PD Modification Application: MM 25-1243

Hillsborough County Florida
Development Services Department

1.0 APPLICATION SUMMARY

AGENCY REVIEW COMMENT SHEET

2.5 Proposed Site Plan (partial provided below for size and orientation purposes. See Section 8.2 for full site plan)

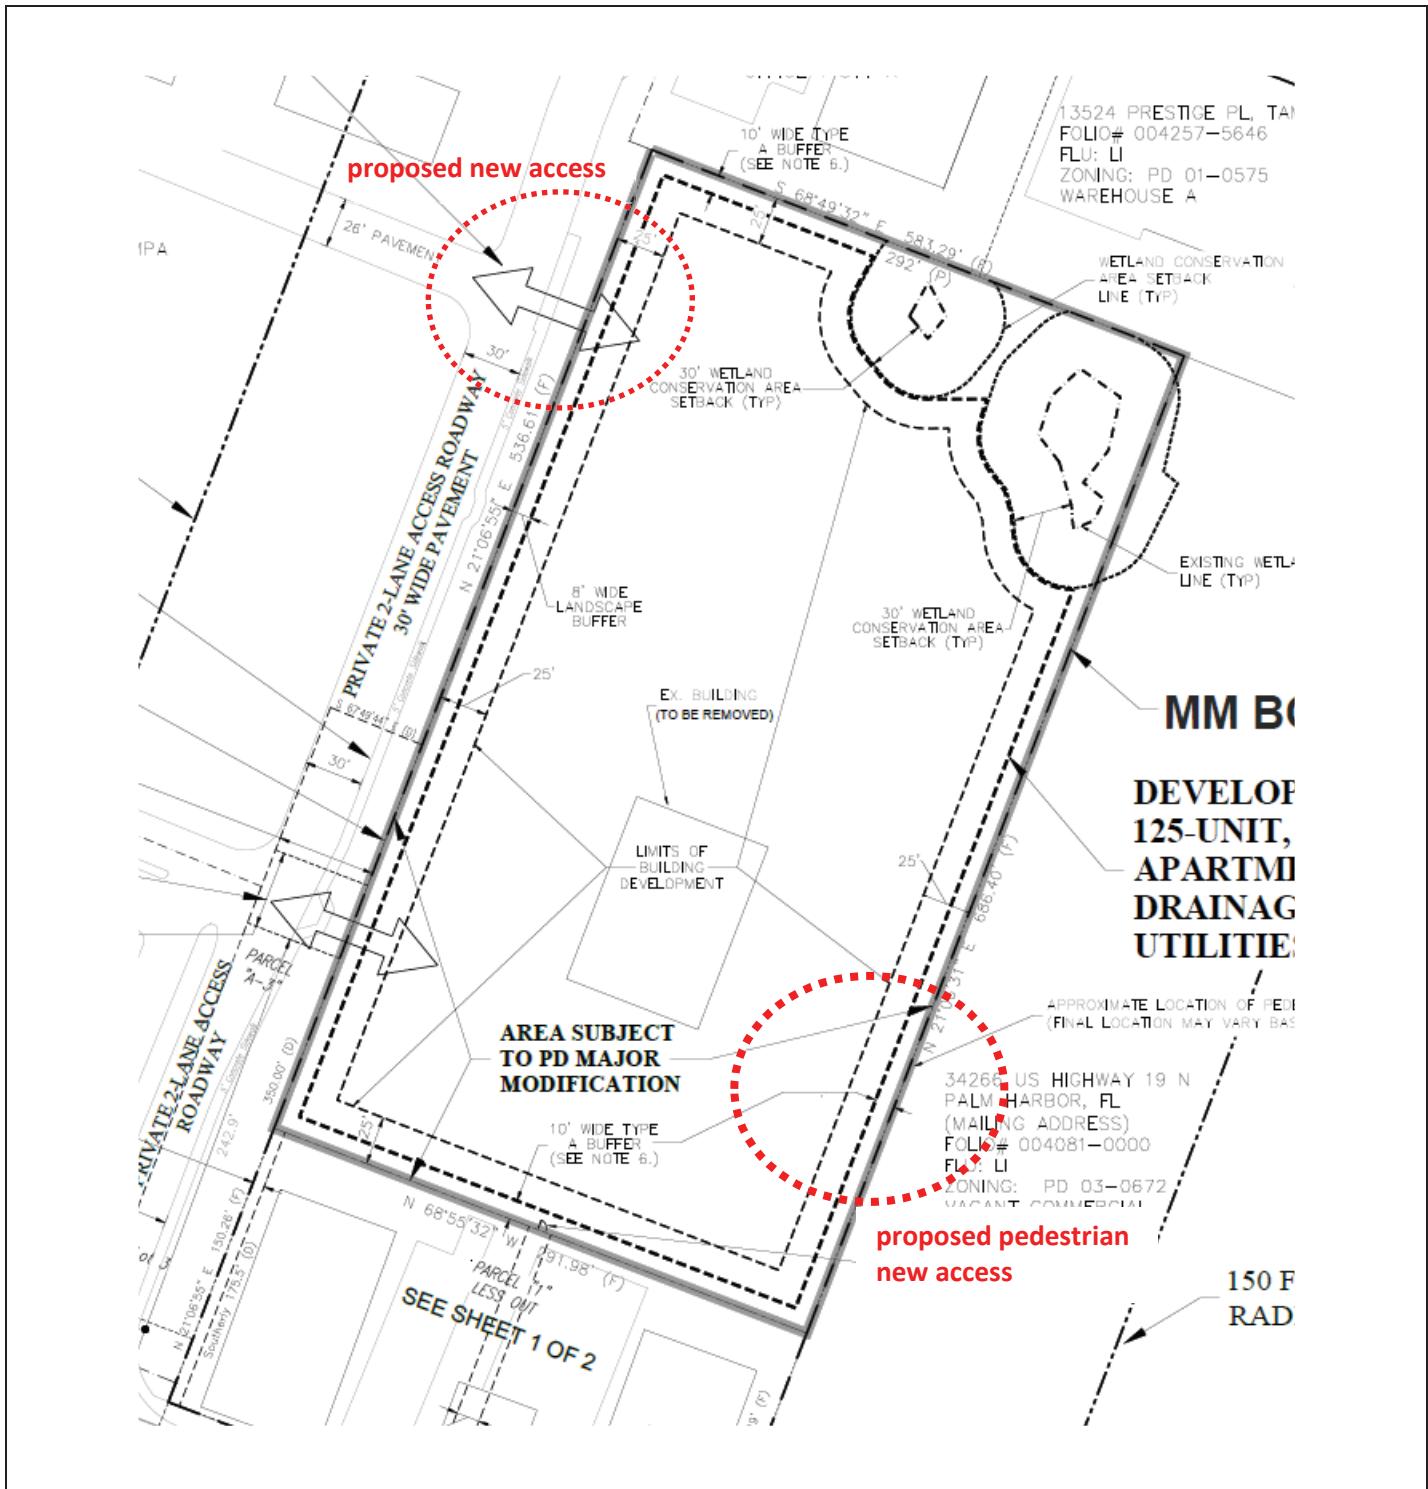
The proposed access modifications are intended to bring the project into compliance with current access management and multimodal connectivity standards. The addition of a vehicular and pedestrian access along the northwest boundary and a pedestrian gate along the south MM 25-1243 boundary.

1. add a vehicular and pedestrian cross access north of (and in addition to) the approved access along the western boundary,
2. change the approved vehicular and pedestrian to a pedestrian only access to Parcel A within the PD zoning, and
3. add a pedestrian cross access to the east.

Approval - Approval of the request, subject to the conditions listed below, is based on the general site plan submitted October 30, 2025.

2. Buildings shall be as generally located on the site plan received October 30, 2025 June 3, 2008, unless a modification is required to avoid impacts to mature trees on the site.

Based upon the information provided by the application, this request is:

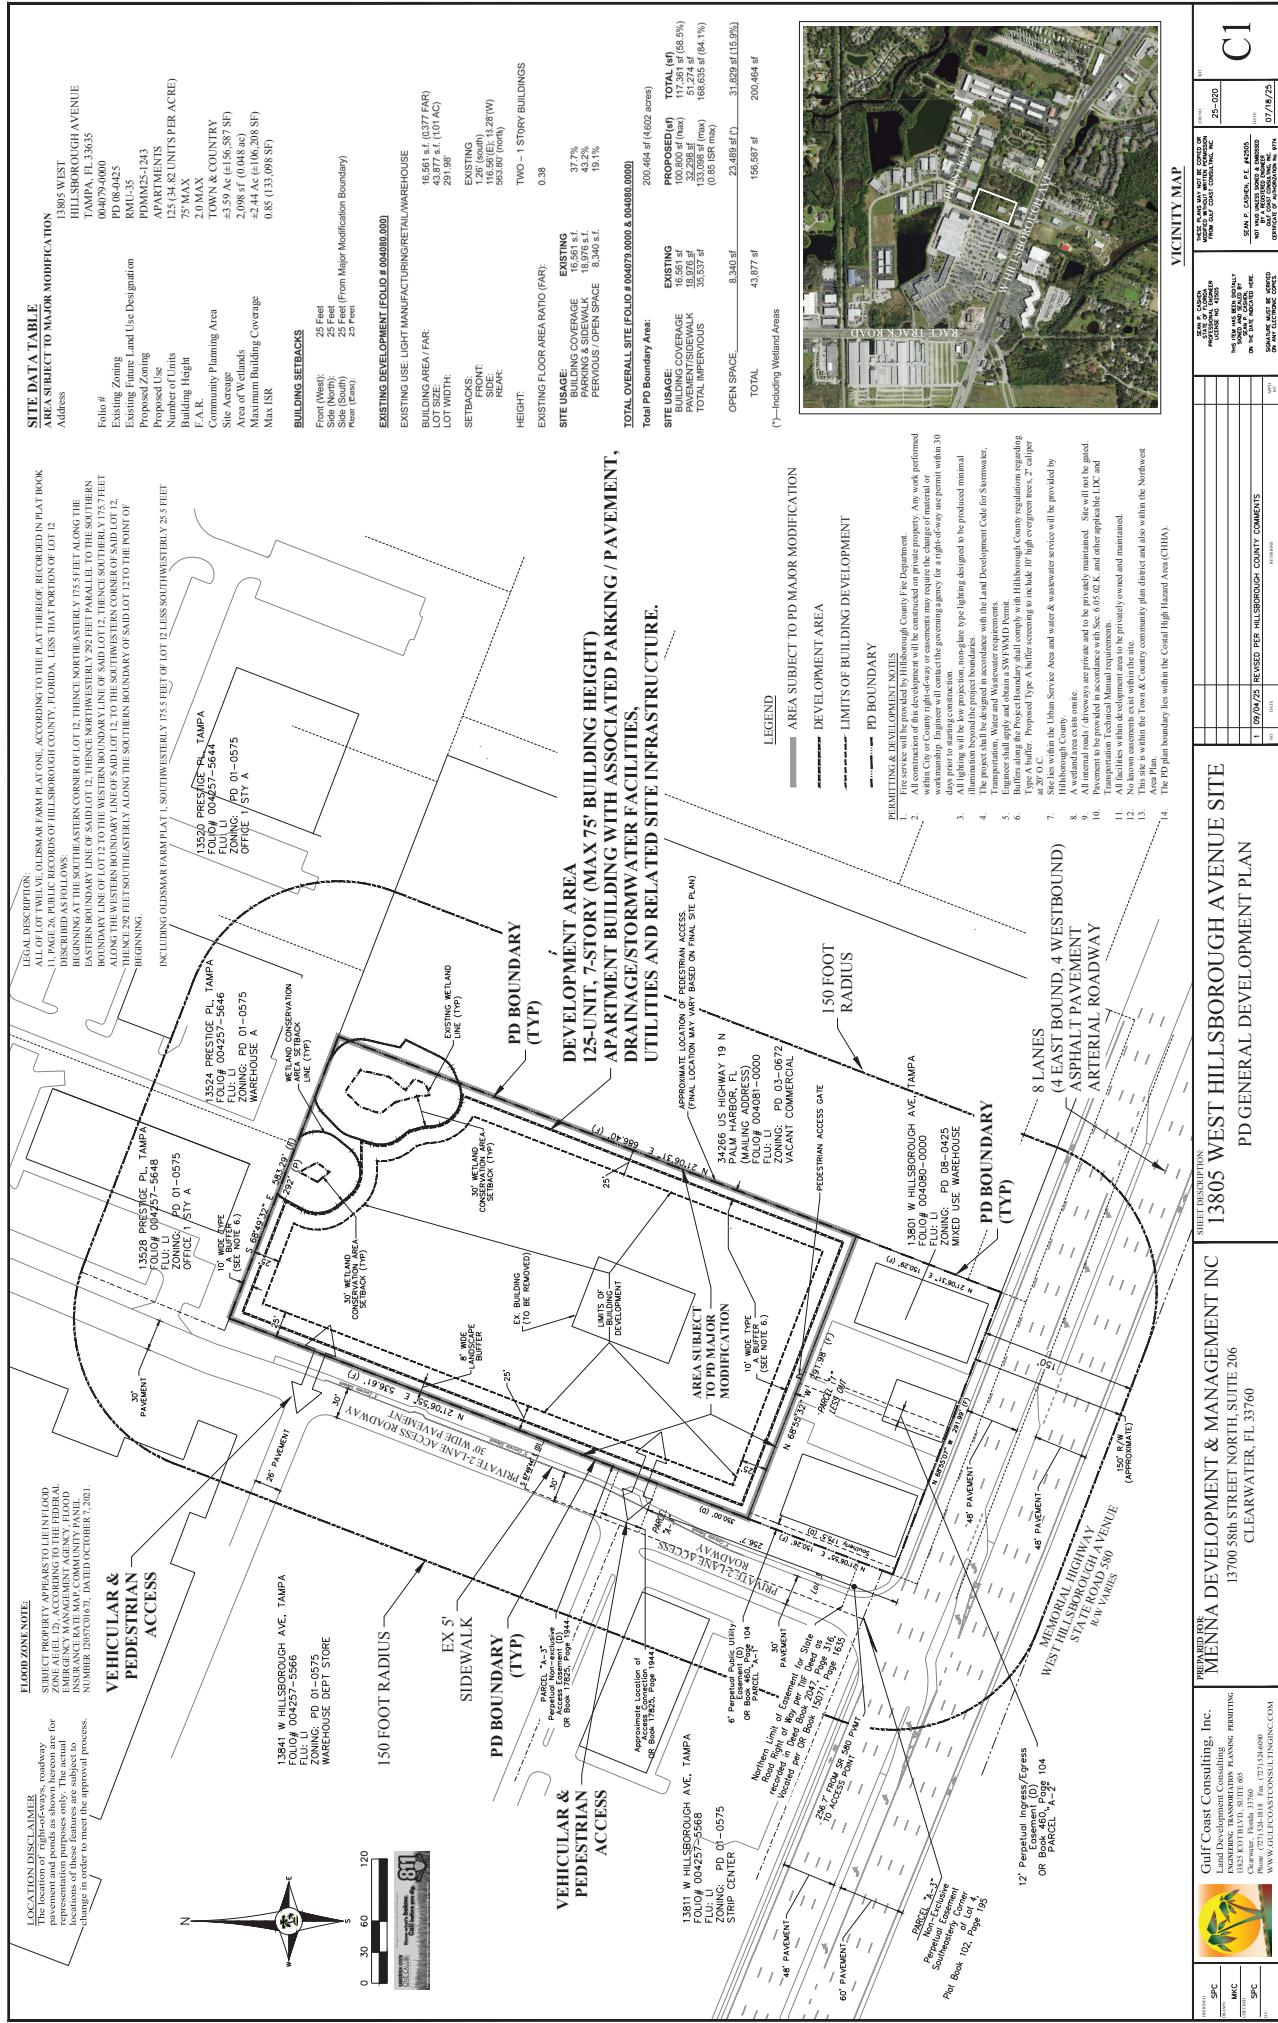
The subject property is under review for the PD rezoning process, as is shown on the attached **PD Site Plan**. This variance is to request that the driveway length to serve this development can exceed the maximum 250 feet per Section 6.04.04.A.3. criteria of driveway length.

- c. Without the variance, reasonable access cannot be provided. In the evaluation of the variance request, the issuing authority shall give valid consideration to the land use plans, policies, and local traffic circulation/operation of the site and adjacent areas. *Due to the location of the existing driveway connection on the west side of private driveway, which the proposed PD Plan driveway access aligns with, without the variance, no other reasonable or safe access point can be provided. Thus, without the variance, reasonable access cannot be provided to this existing private driveway to serve this PD Site.*

As the driveway from Hillsborough Avenue to the proposed multi-family residential units, as shown on the PD site plan, exceeded the maximum length allowed pursuant to County Land Development Code (LDC), Section 6.04.04.A.2. of 250 feet for residential developments, the applicant's Engineer of Record (EOR) submitted a Section 6.04.02.B Administrative Variance request (dated October 10, 2025). Based on factors presented in the Administrative Variance request, the County Engineer found the request approvable (on November 6, 2025).

Disapproved
 Approved with Conditions
 Approved
